Comments on Changes to the Requirements Associated with Braking Compatibility of Semi-Trailers and Centre Axle Trailers as Proposed by Denmark in GRRF-72-7

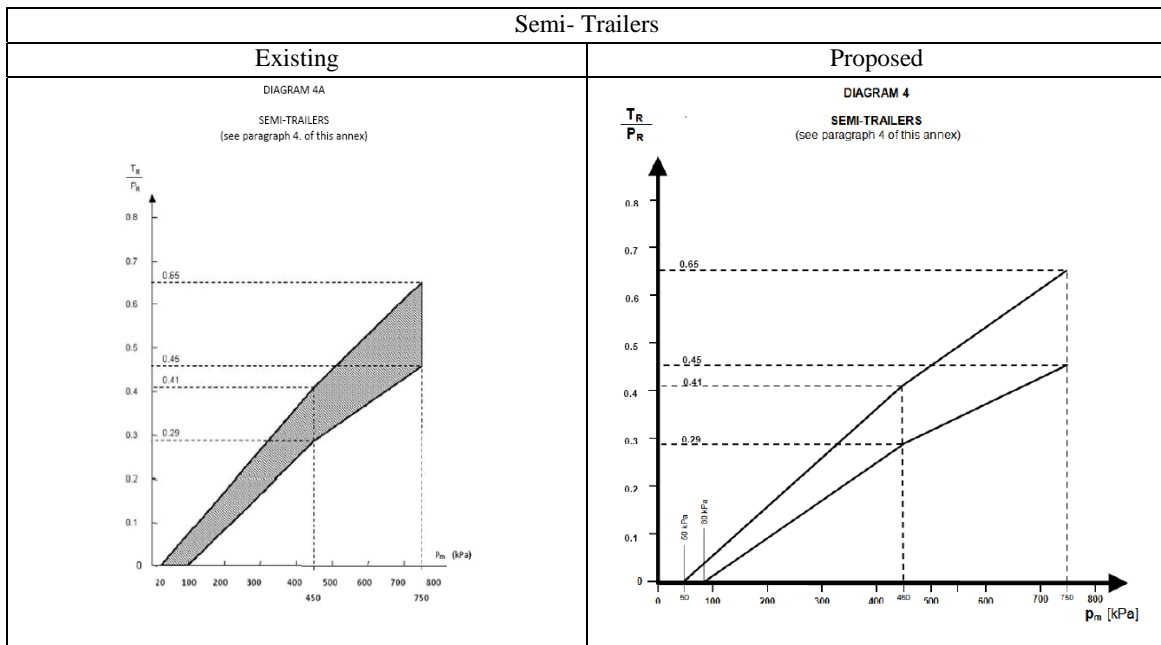
The following diagrams illustrate the current requirements and those proposed by Denmark relating to the Annex 10 compatibility bands for the respective vehicles:

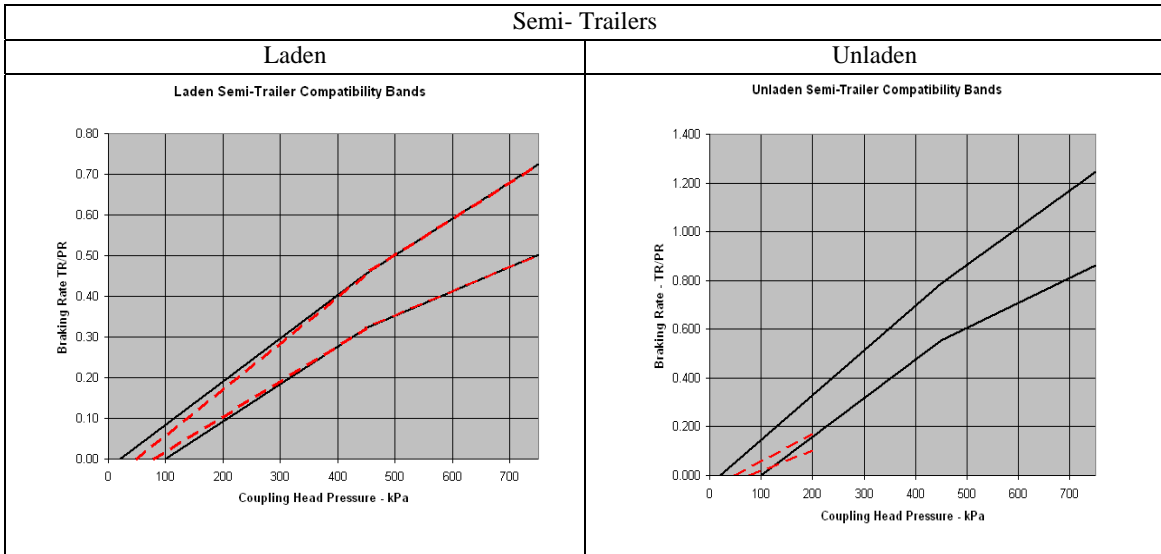
For the laden vehicle the same principle is proposed which is defined for other vehicles in that the laden co-ordinates remain unchanged except that the coupling head pressure range where braking commences is reduced

from 20 to 100kPa to 50 to 80kPa. For unladen semi-trailers it is proposed that braking performance should fall within the revised laden band up to a coupling head pressure of 200kPa. The diagrams below compare the current bands with those proposed for a typical high volume semi-trailer:

The broken red line represents the range of the bands proposed while the solid lines represent the bands determined using the methodology currently prescribed within Annex 10 to Regulation 13.

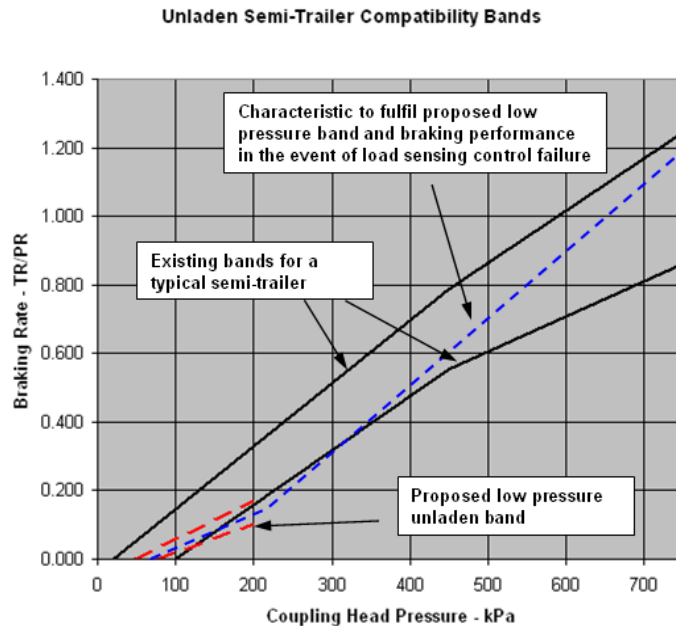
While compliance with the unladen compatibility bands is optional it is common practice for the unladen braking performance to lie within the unladen corridor. The reason for this is that there is a requirement specified with paragraph 6 of Annex 10 that in the event of a failure of the load sensing control the residual braking performance shall be at least 30% of the prescribed laden performance. For the trailer used to determine the bands in the above diagrams the minimum unladen braking rate (T_R/P_R) at a coupling head pressure of 650kPa is 1.01. The following diagram illustrates the characteristic required to fulfil both the proposed low pressure unladen band and load sensing control failure performance:

It can be seen that the relationship of coupling head pressure to generated braking rate is no longer the typical linear relationship. Such a characteristic can only be produced by the brake control system by modifying the

input output relationship of the load sensing control. With electronic brake control this is may be possible but not for a convention pneumatic braking system utilising a conventional load sensing valve.
